RE: POD2023-00275
West Village Revised Pad 3
Construction plan review

RE: POD2023-00349
Gayton Village
POD Initial Review

PROJECT:
Gayton Village
Condominiums
Site, Utility and Lighting Plan
Henric County District, Henric County, Virginia

SHEET:
Layout and Utility Plan

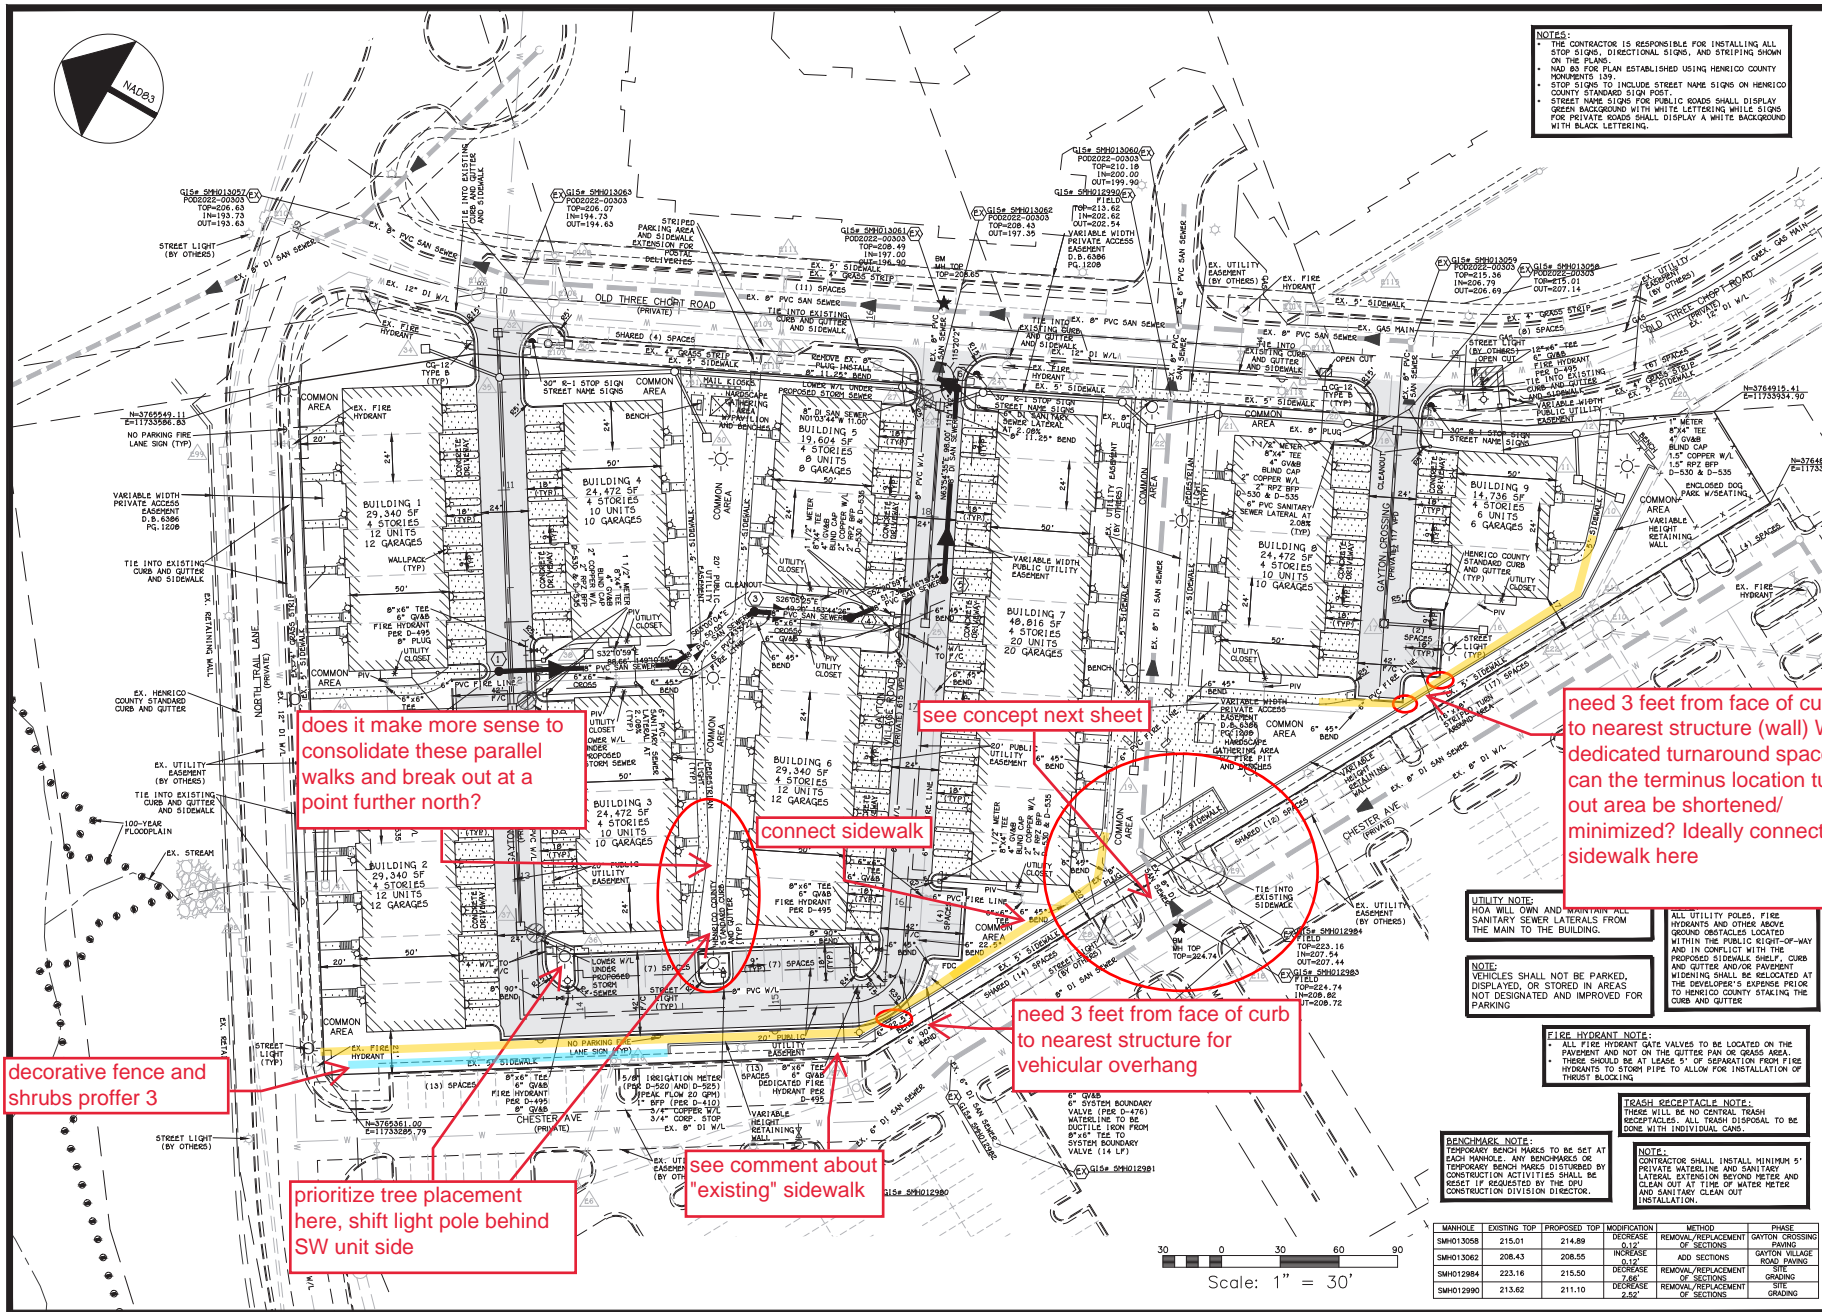
2. Details demonstrating better coordination at the point of connection to the West Village property must be received, in addition to more complete pedestrian connectivity throughout. Recommend a formal hardscape element on raised curb, including a raised planter and furnishings. See plan markup and concept recommendation on sheets following this letter to include elongating the switchback ramp at the connector location.

18. Continue to coordinate with the West Village plan revisions.
19. See following mark up and graphic included herein for clarification of items.
